November 6, 2008

**RE: Comments on Laetitia Agricultural Cluster Subdivision DEIR
SUB2003-00001 (Tract 2606), SCH # 2005041094**

Laetitia Draft EIR Comment Letter
 November 6, 2008
 Page 2 of 7

RRM-3: Existing View

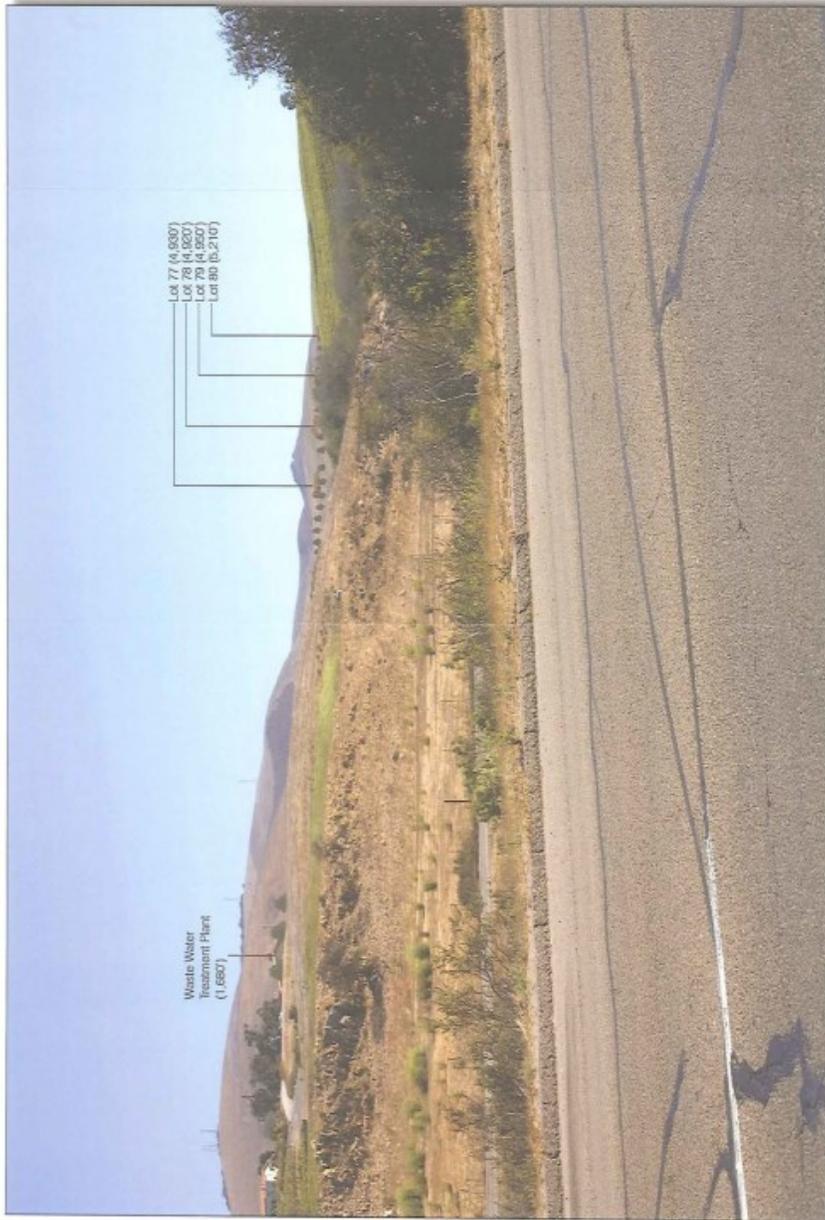
View from Highway 101 Southbound (Reference view KVA-3, DEIR page V-329)

Visual Simulation
 RRM-6; Proposed View
 View from Highway 101 Northbound (Reference view KVA-6, DEIR page V-347)

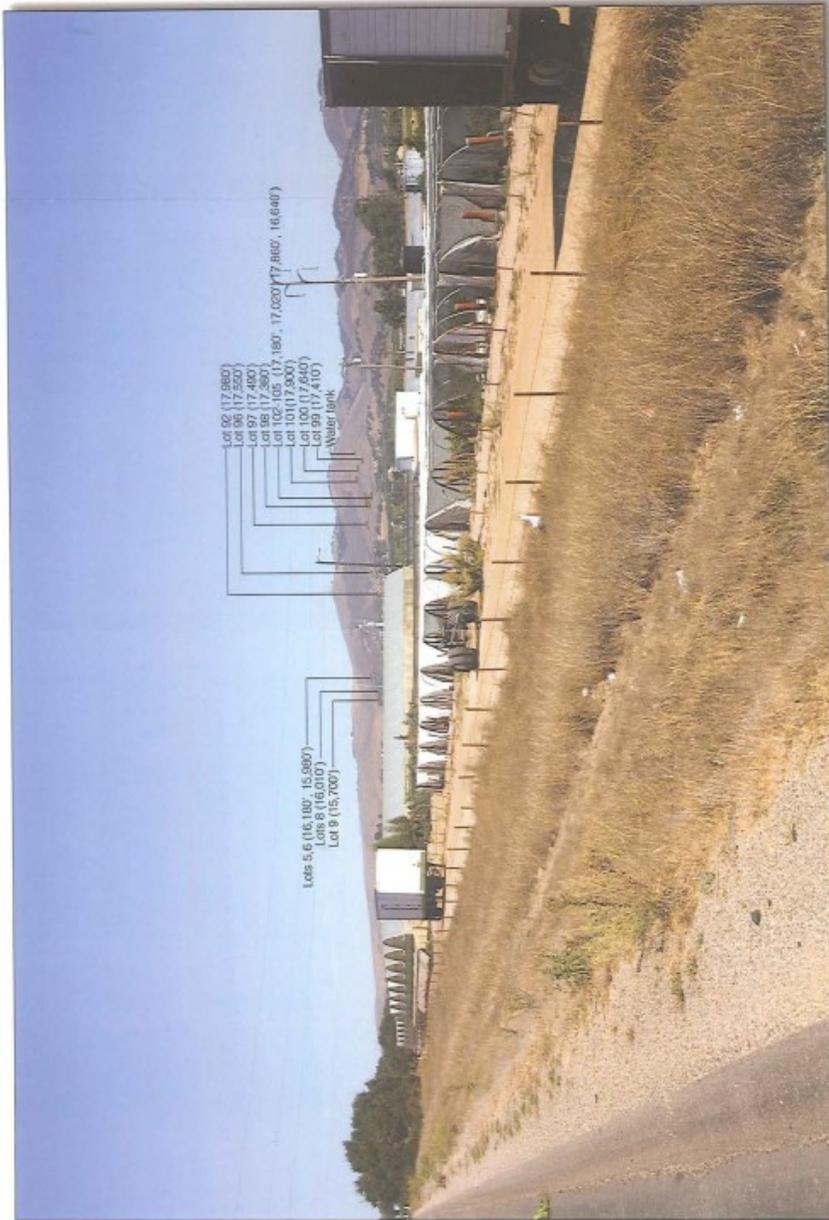
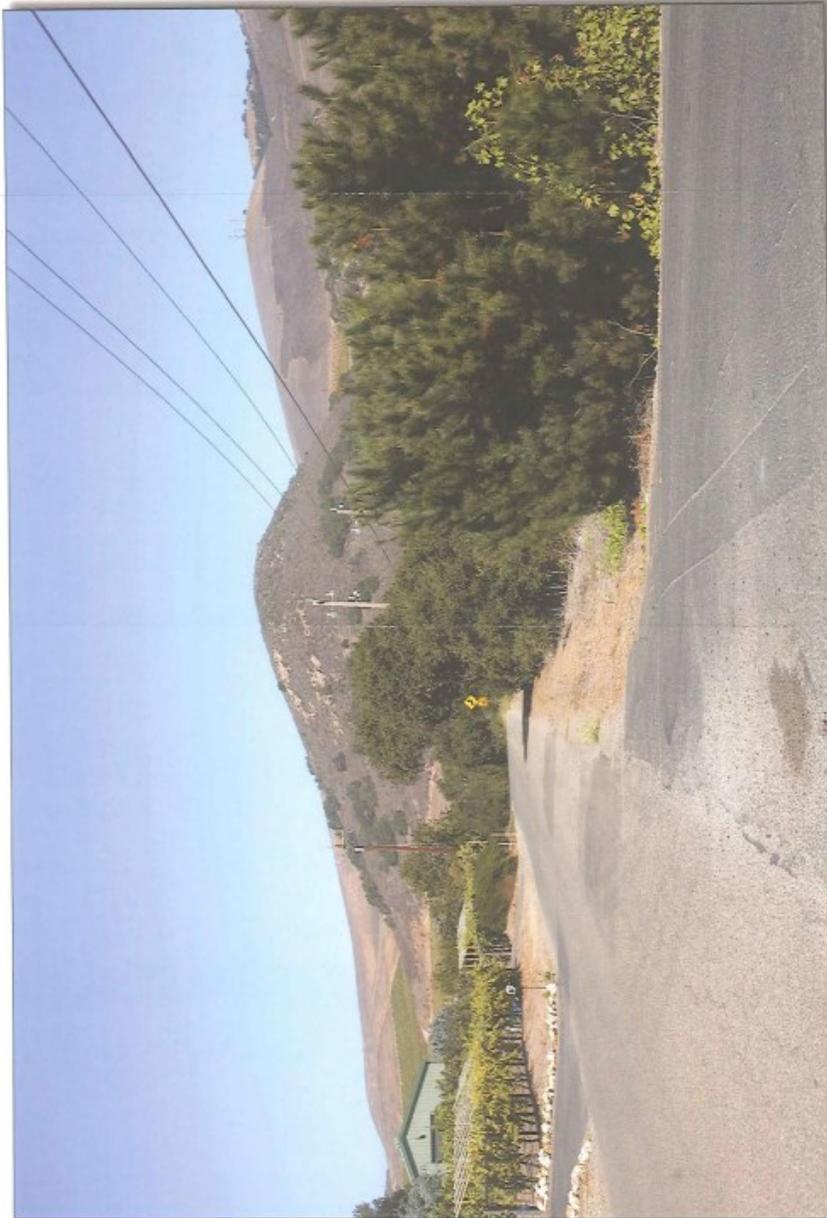
Visual Simulation
RRM-6: Existing View
View from Highway 101 Northbound (Reference view KVA-6, DEIR page V-347)

Figure 2
Stream Flow Measurements
October 13, 2008
Laetitia Agricultural Cluster
Cleath & Associates

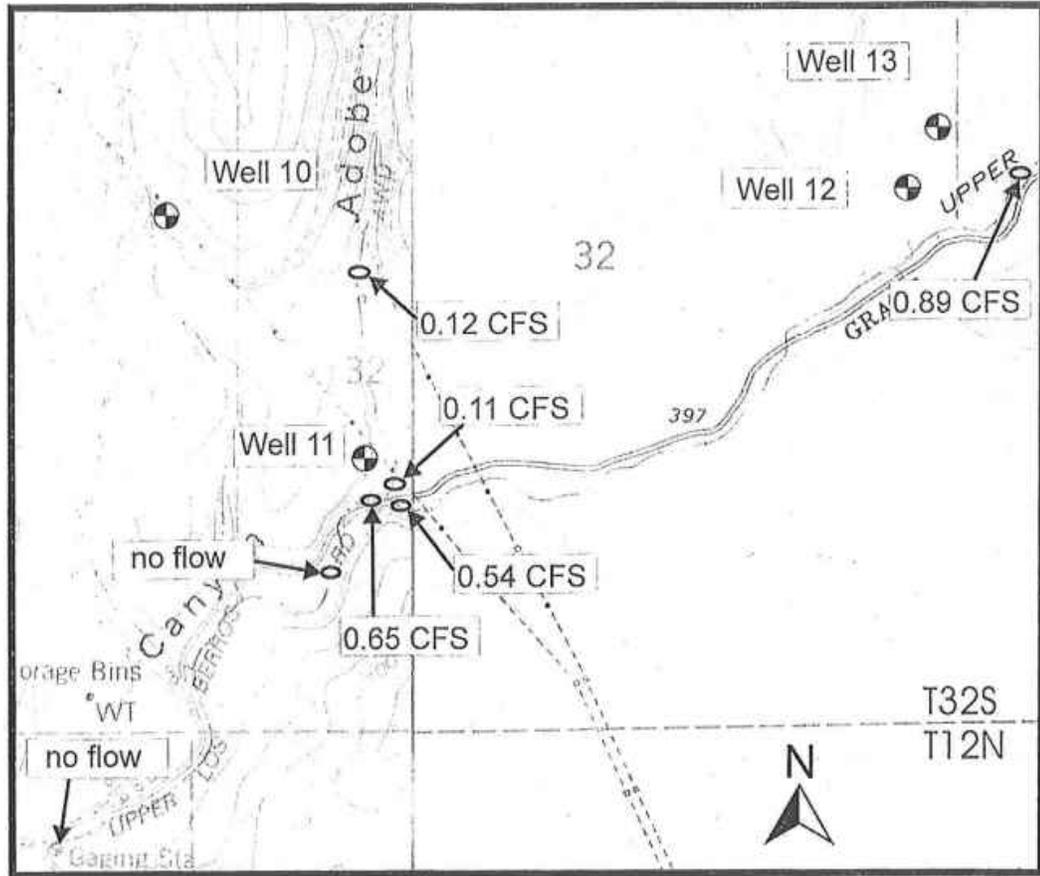
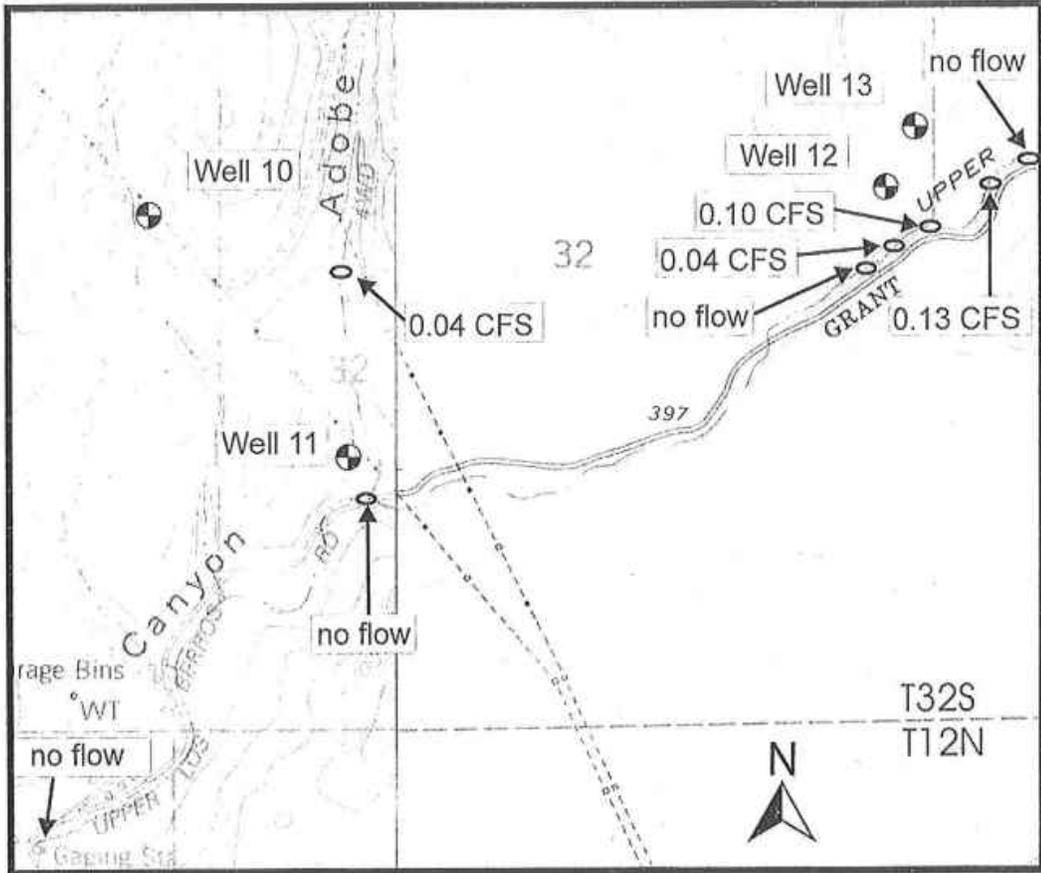
On October 13, 2008, Los Berros Creek was flowing intermittently through the upper canyon, and was dry approaching the upstream Laetitia property boundary. There was a trace of rain in the first week of October (0.13 inches recorded in Arroyo Grande), but drought conditions were still in effect when flow measurements were taken. Flow in the creek began where the Monterey shale aquifer zones for Laetitia Well 12 and Well 13 cross beneath the creek bed. Ground water was observed flowing from fractured rock into the creek at this location. The onset of stream flow where these siliceous shales intercept the creek is likely a combination of seepage from the shale beds and from reduced underflow capacity of the stream bed. Surface flow in the creek continued for approximately 1,000 feet, diminishing gradually until it had completely seeped into the stream gravels as underflow. Further downstream, inflow from Adobe Canyon immediately seeped into the subsurface and did not result in flow on Los Berros Creek.

SUGGESTED NOISE WALL DESIGN

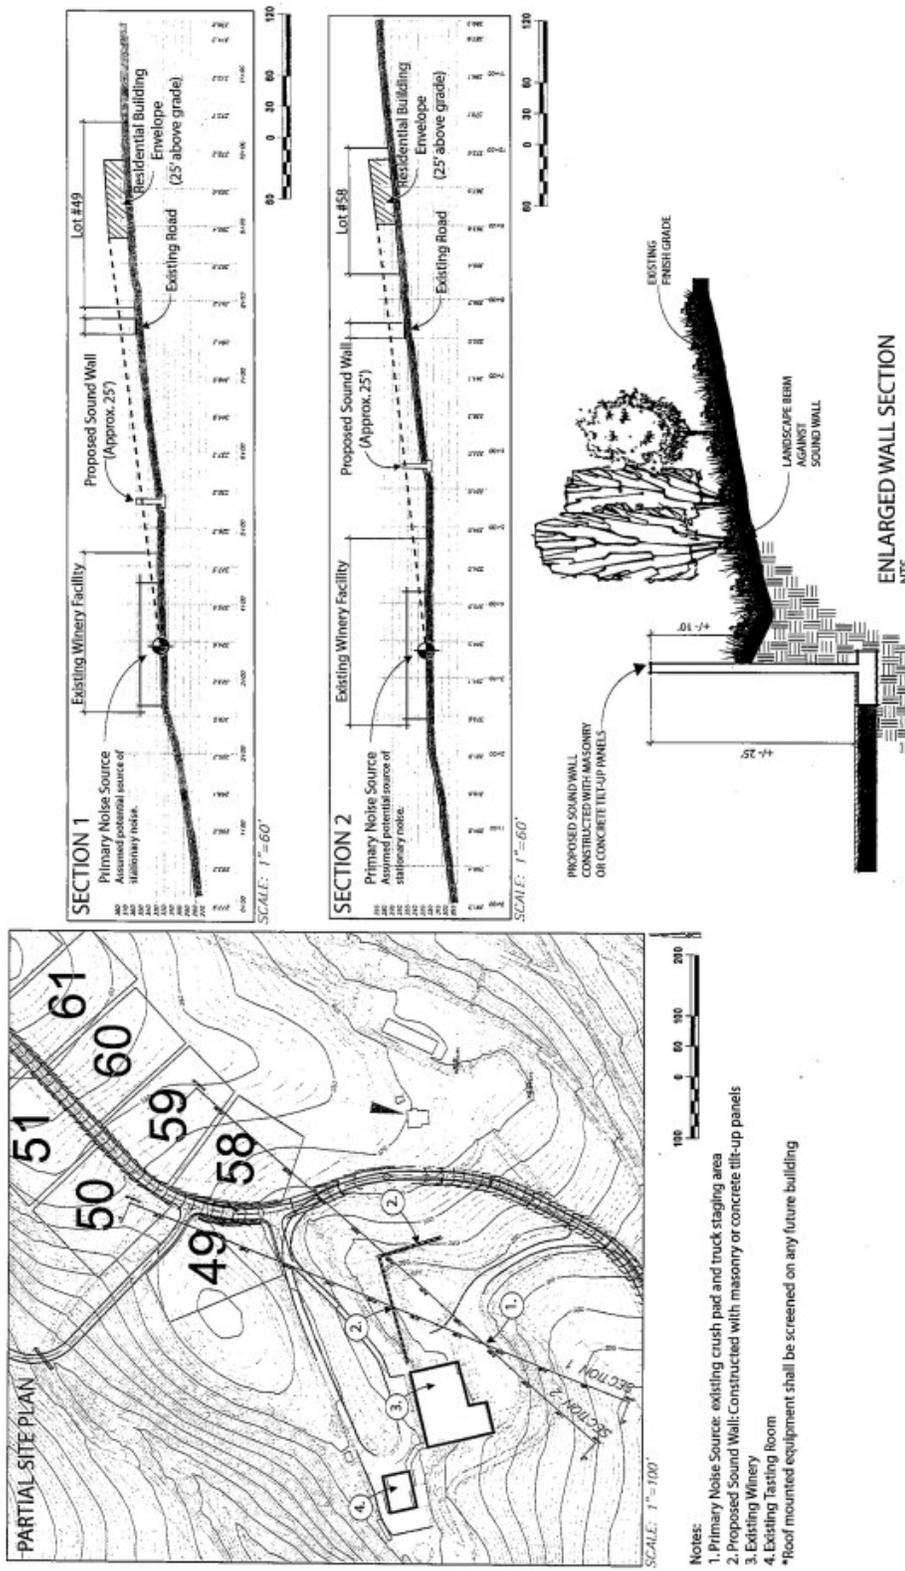
Given the extremely low background noise levels in the area (mainly due to the remoteness from all major roads) and the limited number of times maintenance would occur near any residence, the overall noise environments at these residences will be some of the quietest environments in the County.
